Access Compliance Report

Public Rights-of-Way

(Curb Ramps)

Intersection ID: 42494	Main Street: BULLOCK_GREENWAY_BV	Cross Street: TOLLESON_AV	Location: NE
ADA ID: DBDEBBB5BAE2	Ramp Type: PerpDiag	Initial Pass/Fail: Fail	Overall Compliance: No
Codes/Mitigation Info/Possible Solution			Severity Score: 10
			Field Measurements/Component Compliance

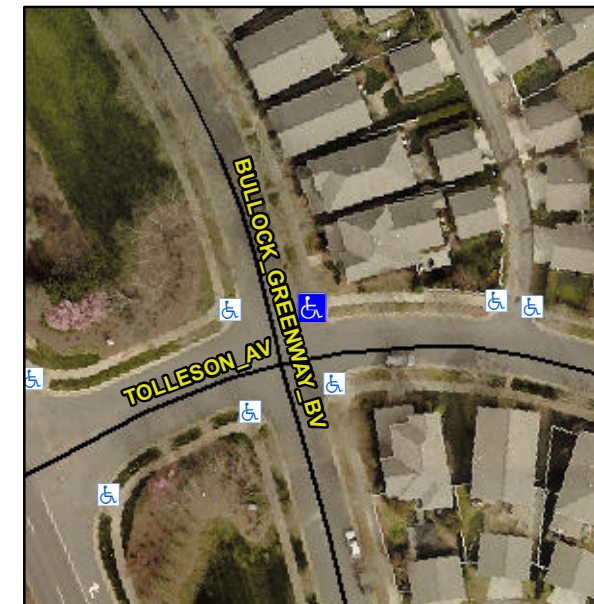
R304.5.1, R304.5.3

Compliance	Description	Data	Compliance	Description	Data
N/A	Ramp Length (in)	72.0	Yes	Ramp Slope (%)	8.1
No	Ramp Width (in)	40.0	No	Ramp XSlope (%)	3.0
N/A	Flare Type LT	N/A	N/A	Flare Type RT	N/A
N/A	Flare Slope LT (%)	N/A	N/A	Flare Slope RT (%)	N/A
N/A	Flare Traversable LT?	N/A	N/A	Flare Traversable RT?	N/A
N/A	Landing Length (in)	N/A	N/A	DWS Provided?	N/A
N/A	Landing Width (in)	N/A	N/A	DWS Contrast?	N/A
N/A	Landing Slope (%)	N/A	N/A	DWS Length (in)	N/A
N/A	Landing X Slope (%)	N/A	N/A	DWS Full Width?	N/A
N/A	Landing Curb? (Y/N)	N/A	N/A	DWS Offset (in)	N/A
N/A	Shared Landing?	N/A			
N/A	Gutter Ponding?	N/A	N/A	Gutter Slope (%)	N/A
N/A	Gutter Lip Ht (in)	N/A	N/A	Gutter X Slope (%)	N/A
N/A	Painted X Walk1?	No	N/A	Painted X Walk2?	No
	X Walk 1 Direction	To W		X Walk 2 Direction	To S
N/A	X Walk 1 Width (in)	N/A	N/A	X Walk 2 Width (in)	N/A
	X Walk 1 Slope (%)	1.3		X Walk 2 Slope (%)	2.8
	X Walk 1 X Slope (%)	1.7		X Walk 2 X Slope (%)	2.4

Remove & Replace Curb Ramp With Two New Directional Ramps or Equivalent.
